PUBLIC INTEREST REVIEW FOR GROUND WATER APPLICATIONS

TO: Water Rights Section Date 13 September 2007
 FROM: Ground Water/Hydrology Section Gerald H. Grondin
Reviewer's Name
 SUBJECT: Application G- 16908 Supersedes review of none
Date of Review(s)

A. GENERAL INFORMATION: Applicant's Name: Blackburn Ranches, L.L.C. (Jett Blackburn) County: Harney

Table showing water-level data for State Well HARN 463, State Observation Well # 167

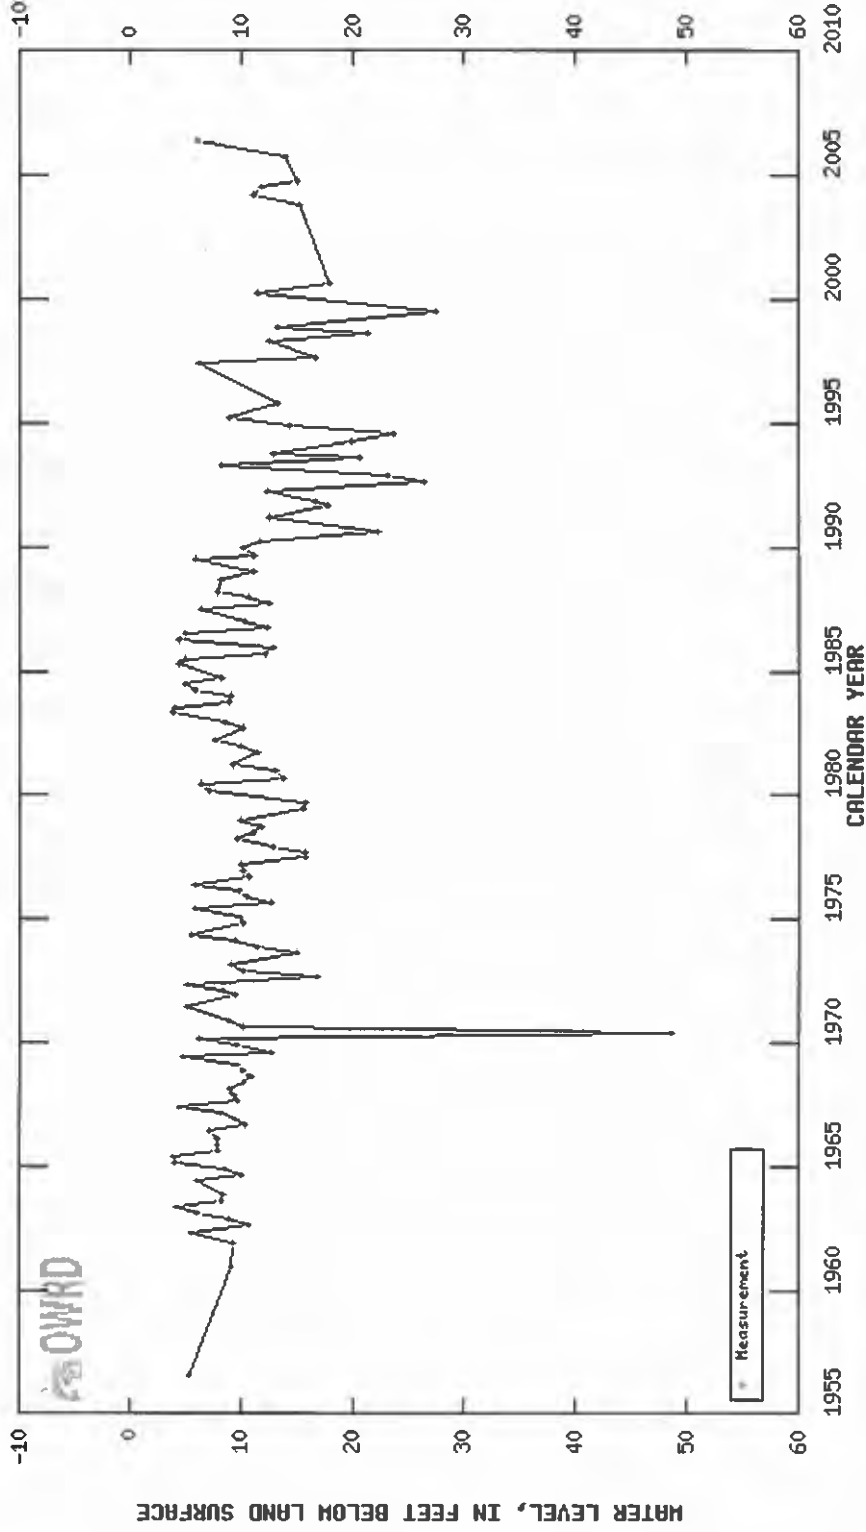
The closest wells with ground water level trend data in the Silvies River sub-basin is well HARN 463 in T23S/R31E-sec 16 (about 13.1 miles to the northwest) and in the Harney-Malheur Lakes sub-basin are wells HARN 547 in T23S/R32E-sec 07 (about 11.5 miles to the northwest) and HARN 741 in T23S/R34E-sec 31 (about 13.0 miles to the northeast). All are completed in sediments. All three are in basin fill sediments upgradient of the applicant's wells. Well HARN 463 appears to be in a recharge area, wells HARN 547 and HARN 741 do not. The ground water level data for HARN 463 and HARN 547 is from 1960 to 2006 and for HARN 741 is from 1974 to 2006. The ground water level trend for the three sites show seasonal and climatic influences. No decline is apparent at HARN 463, but a possible net decline of less than 5 feet may have occurred at both HARN 547 and HARN 741 sites. Interestingly, no recovery of the annual trend is apparent at HARN 547 and HARN 741 from 1996 to 1999, a generally wetter than average period in Oregon. Seasonal ground water level fluctuations range from 5 to 15 feet at HARN 463 and 10 to 40 feet at HARN 547 and HARN 741. This could adversely impact the use of shallow wells, but likely not adversely impact the use of deeper wells.

Well 1 (HARN 51322, G-16908) to Silvias River

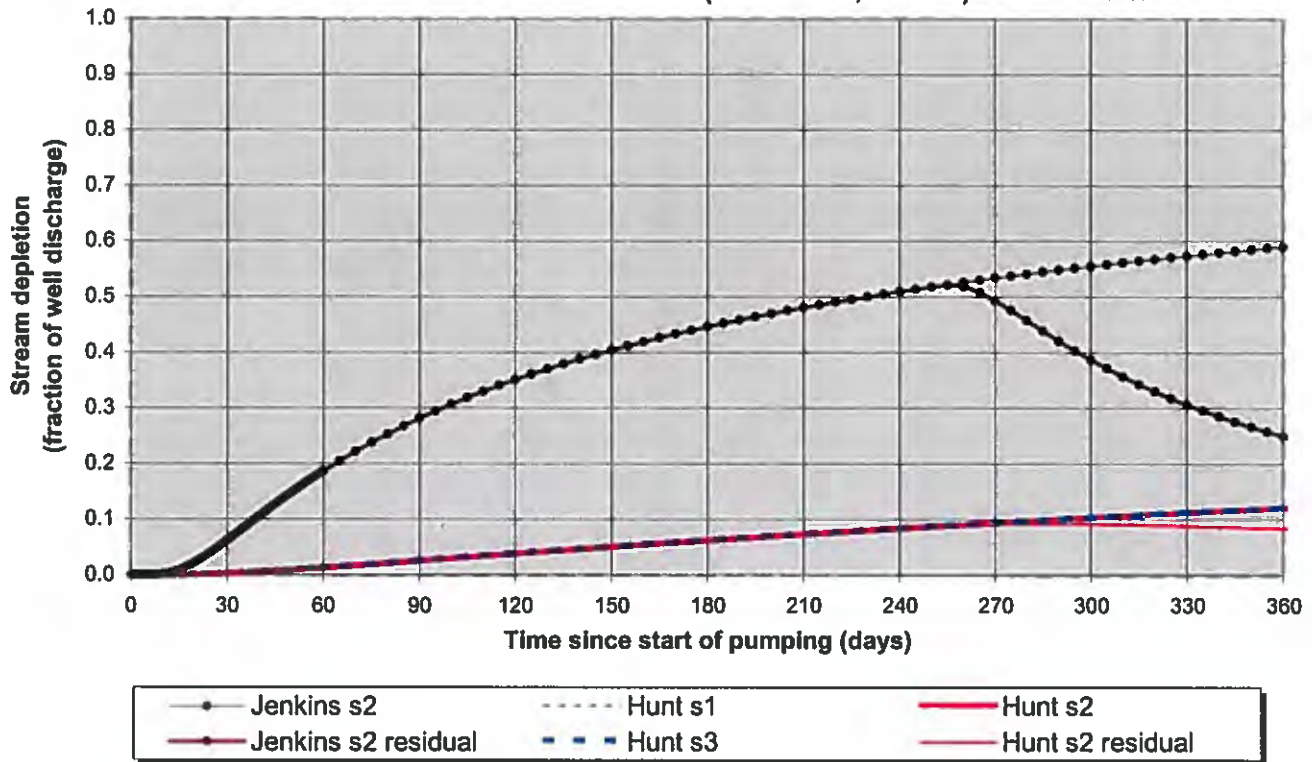
Hunt (1999) was used to calculate the interference at Silvies River given the well will likely not penetrate the basin fill sediments. The values used for the calculations are conservative and appropriate until better values become available. The calculations used a transmissivity of 7,500 ft²/day which is consistent for Eastern Oregon basin fill transmissivities noted by Gonthier (1985) and transmissivity values derived from specific capacity data from wells in T23S/R32.57E-sec 10, 13, 14, 15, 16, 22, 24, 30, and 31 (HARN 564, HARN 641, HARN 642, HARN 645, HARN 648, HARN 649, HARN 650, HARN 651, HARN 657, HARN 955, HARN 958, HARN 959, HARN 968, HARN 1861, HARN 1870, HARN 2039, HARN 50054, HARN 50491, HARN 50514, and HARN 51204). Additionally, the calculation used an assumed intermediate storage coefficient (0.001). The hydraulic conductivity assigned to the bed of the tributary is 0.20 feet/day.

Well 1 (HARN 51322, G-16908) to Ninemile Slough

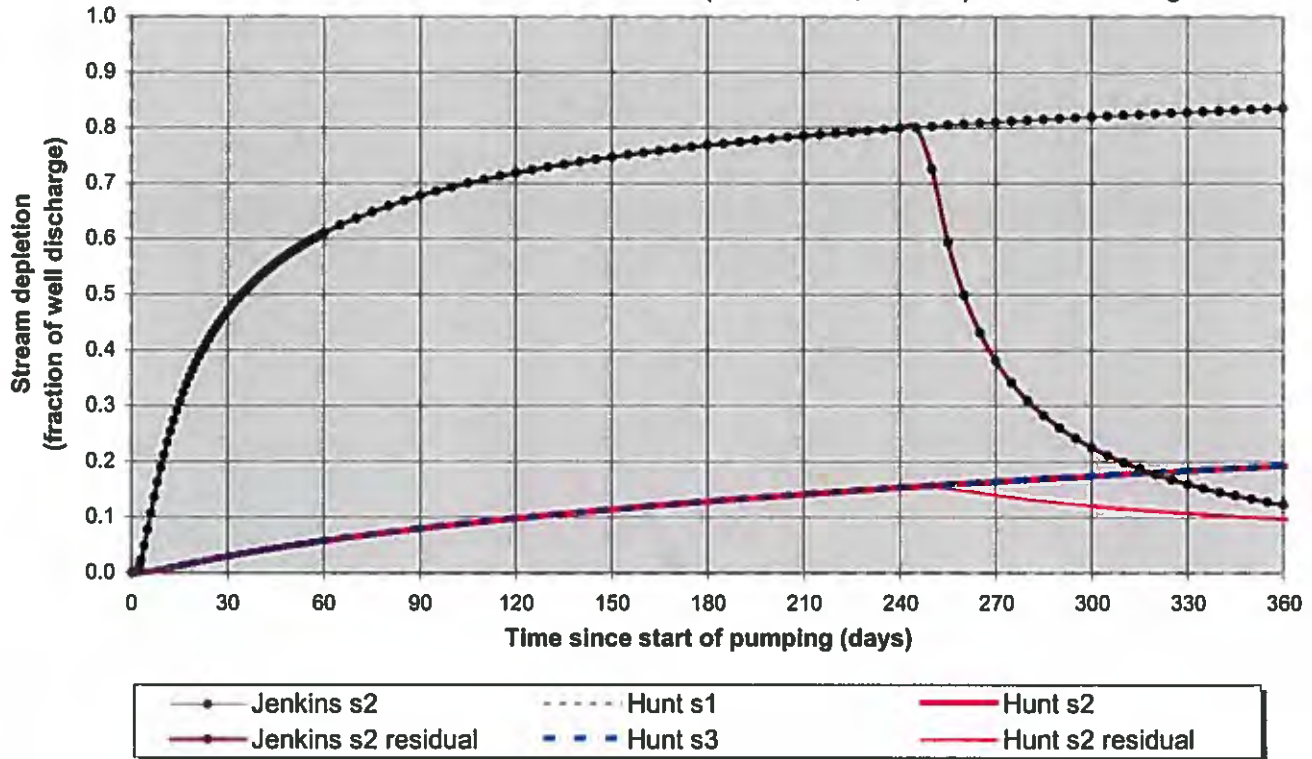
Hunt (1999) was used to calculate the interference at Ninemile Slough and tributaries given the well will likely not penetrate the basin fill sediments. The values used for the calculations are conservative and appropriate until better values become available. The calculations used a transmissivity of 7,500 ft²/day which is consistent for Eastern Oregon basin fill transmissivities noted by Gonthier (1985) and transmissivity values derived from specific capacity data from wells in T23S/R32.57E-sec 10, 13, 14, 15, 16, 22, 24, 30, and 31 (HARN 564, HARN 641, HARN 642, HARN 645, HARN 648, HARN 649, HARN 650, HARN 651, HARN 657, HARN 955, HARN 958, HARN 959, HARN 968, HARN 1861, HARN 1870, HARN 2039, HARN 50054, HARN 50491, HARN 50514, and HARN 51204). Additionally, the calculation used an assumed intermediate storage coefficient (0.001). The hydraulic conductivity assigned to the bed of the tributary is 0.20 feet/day.
